QANTAS GROUP FLIGHT TRAINING CENTRE FLOOD IMPACT ASSESSMENT

FLOOD IMPACT ASSESSMENT

QANTAS Group Flight Training Centre Peer Review of TUFLOW Model

QANTAS FLIGHT TRAINING FACILITY TUFLOW MODEL REVIEW

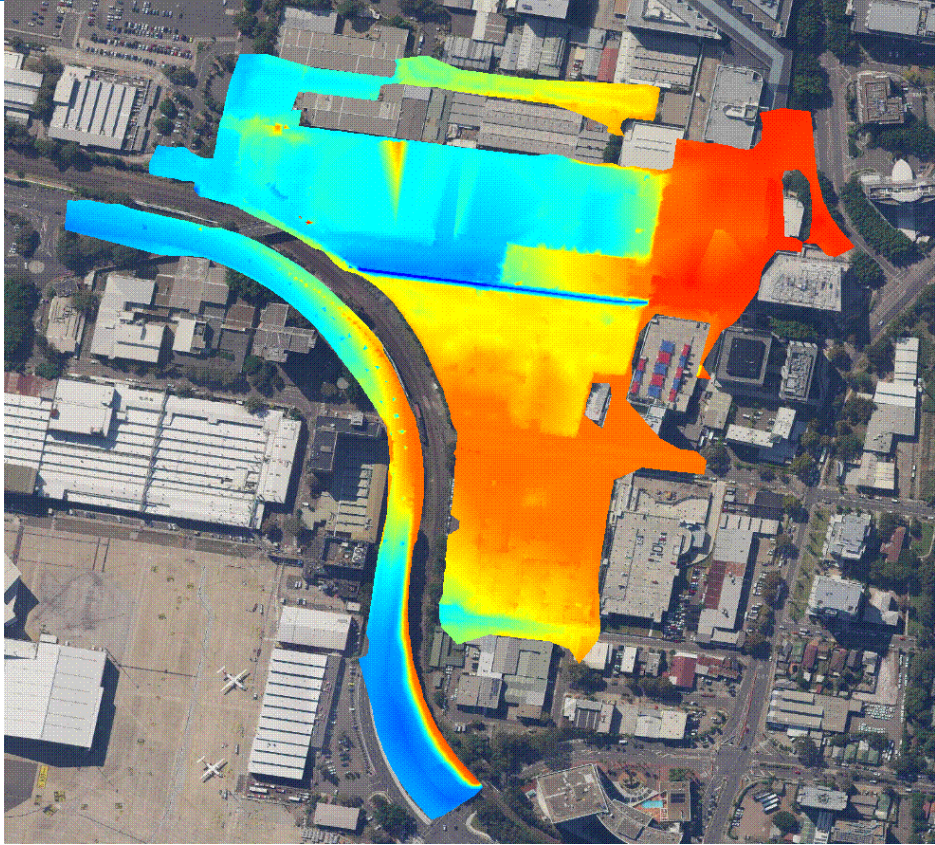
ITEM	REQUIREMENTS / CRITERIA	COMMENTS	REQUIRED UPDATES	ACTION
Extent of Model	2D Model Extent	<ul style="list-style-type: none"> Active 2D domain extent set by 2d_code_StudyArea_003 Subject site located sufficiently within active domain to ensure appropriate representation of upstream and downstream flood conditions 	Nil	
	1D Model Extent	<ul style="list-style-type: none"> Major open creek channels and structures within the catchments including channel adjacent subject site. Cross section geometry agrees well with detailed site survey, and is a significant improvement over the LiDAR representation, justifying the use of 1d elements. 	Nil	
Terrain Data (2D)	Source of DEM data	<ul style="list-style-type: none"> Catchment wide terrain assigned through z-points populated from 2013 LiDAR data (2d_zpt_MRE). Additional zshp (2d_zsh_en_terrain_fix) included to 'fix' terrain where topography has changed since data collection, ie: a building on corner of Bourke Rd and O'Riordan St which was an open carpark (left image below) at the time of LIDAR collection, and now has a large building complex present (right image below).  <ul style="list-style-type: none"> Detailed survey DEM (existing_190220.asc) included across and around the development site (extent shown below). 	Nil

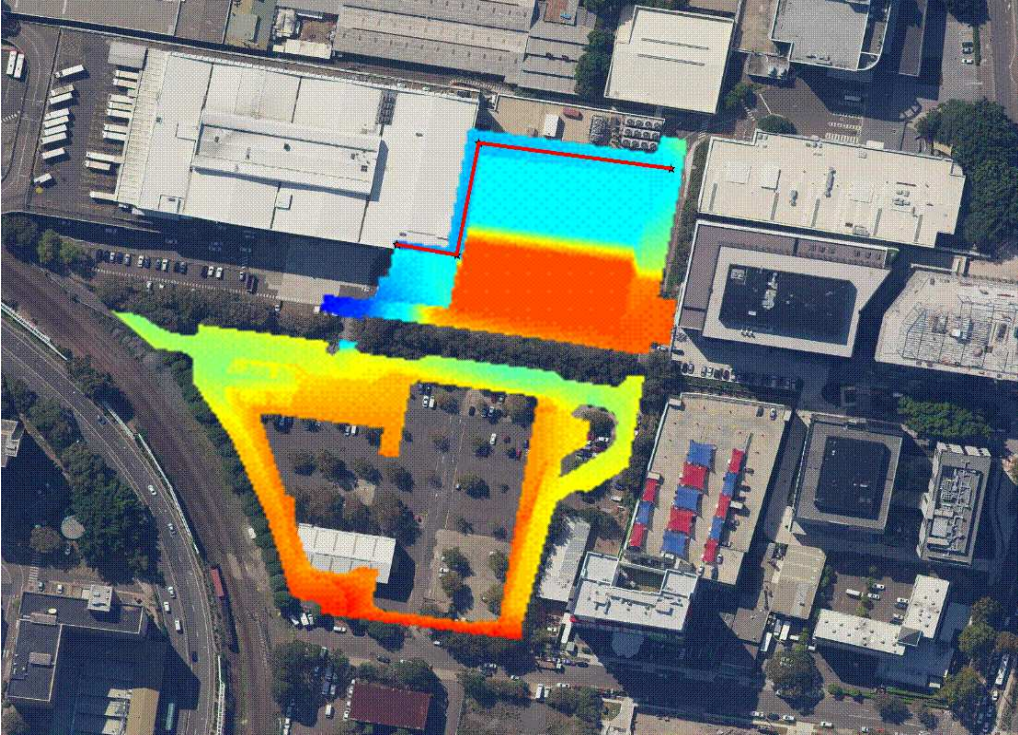
ITEM	REQUIREMENTS / CRITERIA	COMMENTS	REQUIRED UPDATES	ACTION
		 <p data-bbox="629 1150 1682 1469"> For the most part, there appears to be a good agreement between the 2013 LiDAR terrain and the detailed site survey (generally within 0.05m). However, a location ~50m west from the Bourke Road frontage of the site demonstrates a more significant difference of 0.15 metres, where the detailed survey is higher than the 2013 LiDAR DEM (see section provided below). The detailed survey appears to better reflect the crest of the driveway and has been collected more recently, using more accurate ground survey techniques. As a result, it is considered that the ground survey information is superior to the LiDAR and is more suitable for use in the TUFLOW model across this area. </p>

ITEM	REQUIREMENTS / CRITERIA	COMMENTS	REQUIRED UPDATES	ACTION
		 <p>The image shows an aerial photograph of a building complex. A yellow arrow points to a specific area on the roof or courtyard. Below the photograph is a 'Cross Section' graph. The graph plots elevation in meters (y-axis, ranging from 8.20 to 8.55) against distance in meters (x-axis, ranging from 0 to 30). Two data series are shown: a green line representing a proposed terrain DEM and a red line representing an existing zshp. The green line shows a peak elevation of approximately 8.55 meters at the 15-meter mark, while the red line remains relatively flat around 8.30-8.35 meters.</p> <p>• The post development scenario includes a proposed terrain DEM (190716-proposed.asc), and a zshp (2d_zsh_en_north_olf_L , 2d_zsh_en_north_olf_P) to enforce an overland flowpath on the site that allows water movement along the northern and western extents of the proposed carpark (extent of proposed DEM shown below, and overland flowpath z shape shown as a red line)</p>

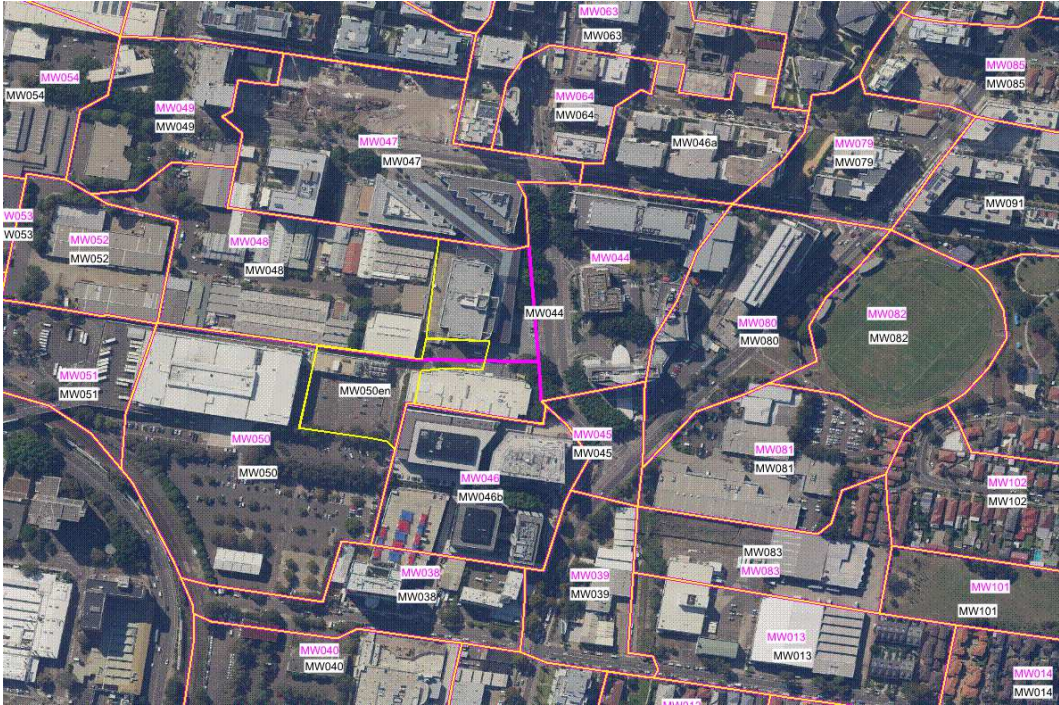
ITEM	REQUIREMENTS / CRITERIA	COMMENTS	REQUIRED UPDATES	ACTION
Stormwater Network	Representation	<ul style="list-style-type: none"> The TUFLOW model includes a representation of the stormwater drainage system within the catchment. However, a number of stormwater pipes at the top of drainage lines have been set to “ignored”. This appears to be unchanged from the original MRE Flood Study model and is assumed to be intentional. 	Nil	
Boundary Conditions	Inflow boundary conditions -	<ul style="list-style-type: none"> Inflows to the TUFLOW model have been defined using flow hydrographs generated by a DRAINS model and are applied to the 2D domain based on a 2d_SA layer with 'Local' inflow hydrographs applied. The subcatchments/SA polygons in the vicinity of the site have been compared between that used within the original MRE Flood Study and that used within the current study. It has been identified within the current study, and verified within this review, that subcatchment “MW046” was originally representing two geographically separate catchment areas as a single subcatchment. As a result, flows were being inappropriately distributed to the 2D domain. This appears to be rectified within the current study by separating the two subcatchments in the DRAINS model, re-naming them MW046a and MW046b and applying the flows from both subcatchments separately to the TUFLOW model. The updates within the DRAINS model to facilitate this update have been reviewed and appear reasonable. A refinement of the subcatchments, MW044, MW048 and MW050, which are in the vicinity of the study site, have also been made to better reflect the surveyed topography (particularly across the high point identified in the review of the detailed survey DEM). It has also allowed a more detailed and reliable application of local flows in the immediate vicinity of the site. The updates within the DRAINS model to facilitate this update have been reviewed and appear reasonable. Note that the underlying model hydrology has not been reviewed. Subcatchment MW044 was also enlarged (in a westerly direction) to the high ground identified in the detailed site survey. MW048 and MW050 were reduced to balance the expanded subcatchment MW044. A new subcatchment was added within MW050, (named MW050en) to allow more detailed application of flow within the site (e.g., the low point in the car park for the existing scenario). The SA polygon boundaries and labels from the original MRE Flood Study are shown in pink and the 	Nil

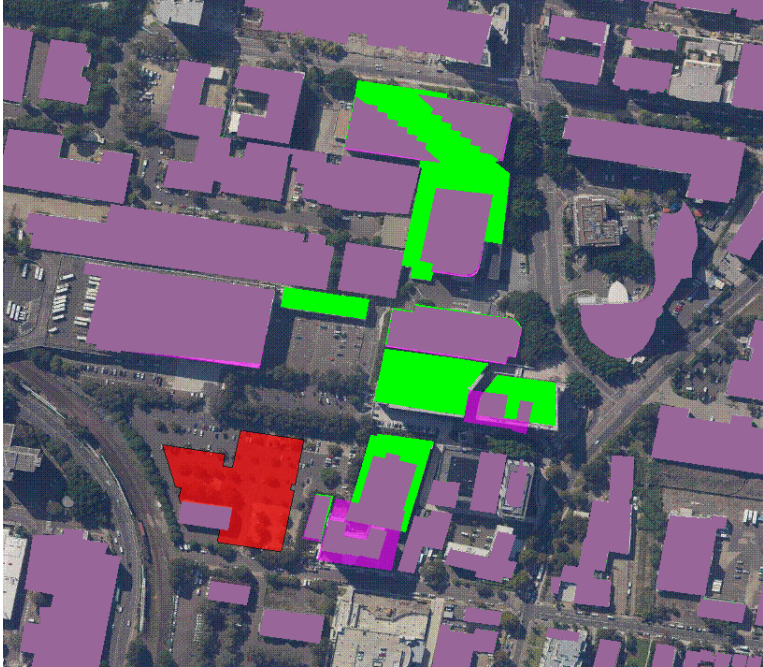
ITEM	REQUIREMENTS / CRITERIA	COMMENTS	REQUIRED UPDATES	ACTION
		<p>yellow boundaries and black text represents the modified subcatchment boundaries used in the current study.</p>  <p>• The flow application location from the refined subcatchment MW050en has been altered between the “existing” conditions and “proposed” conditions models to account for the location of the proposed carpark. In the proposed conditions model, this is applied directly to the overland flowpath skirting around the carpark. As this will be the lowest point in the area, this is reasonable.</p>		
	Downstream boundary conditions	<p>• Unchanged from original MRE Flood Study model. Located a sufficient distance downstream of site to not impact directly on results at the site itself.</p>	Nil	
Flowpath Obstructions	Buildings	<p>• Buildings have been represented within in the model as complete flow obstructions by complete removal of the 2d cells contained within building footprints.</p>	Nil

ITEM	REQUIREMENTS / CRITERIA	COMMENTS	REQUIRED UPDATES	ACTION
<p>and Constrictions</p>		<ul style="list-style-type: none"> Buildings in the vicinity of the site have been modified to better reflect contemporary conditions. Green buildings are from the original flood model, pink/purple are overlaid from the modified existing conditions model, and the red polygons are the modified buildings for the post development scenario. The modified location and extents of buildings for both existing and post development scenarios as part of this study are considered appropriate for use. 		
<p>Model Parameters</p>	<p>Roughness (Manning's 'n') values</p>	<ul style="list-style-type: none"> Unchanged from original MRE Flood Study model. All Manning's 'n' values are within reasonable ranges. Material polygons implemented as part of post-development model are unchanged compared to existing conditions. As the modified carpark is currently a carparking area, and the new flight training facility building is represented as null 2d cells, it is considered reasonable to retain the existing material definition in the post development scenario. 	<p>Nil</p>
